ADDENDUM 3 CSP 22-136

EDINBURG NORTH HIGH SCHOOL HEATING & AIR CONDITION (HVAC) IMPROVEMENTS FUNDED THROUGH THE ELEMENTARY & SECONDARY RELIEF (ESSER) FUNDS August 31, 2022

ADDENDUM 3 NARRATIVE

Subject: Addendum No. 3

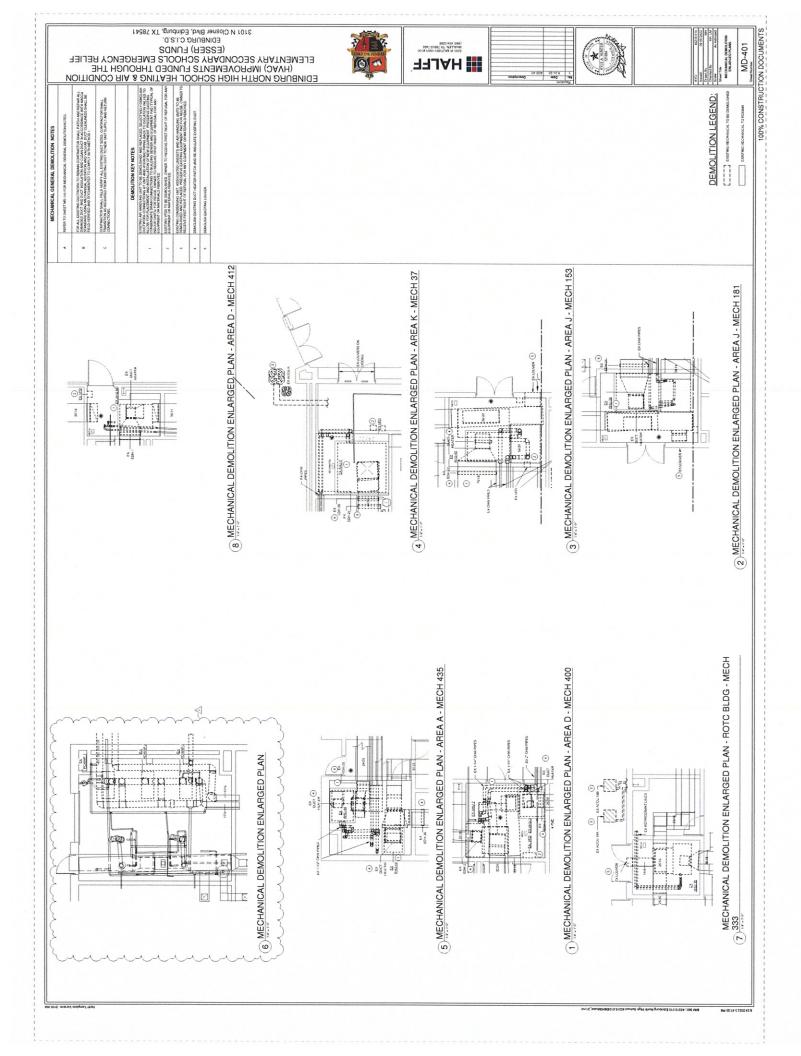
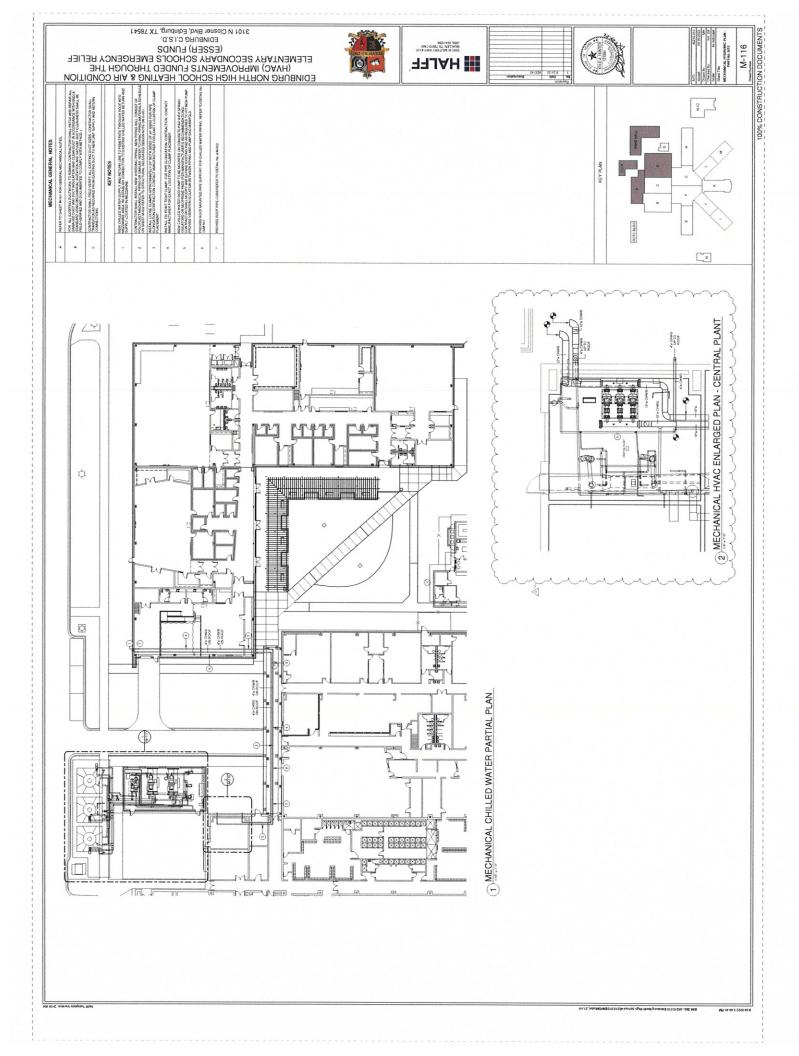
ITEM 2: SHEET MD401

Sheet updated

(1) MECHANICAL HVAC ENLARGED PLAN - AREA J - MECH 153

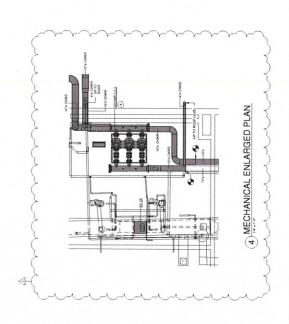
ITEM 3: SHEET M116

Sheet updated
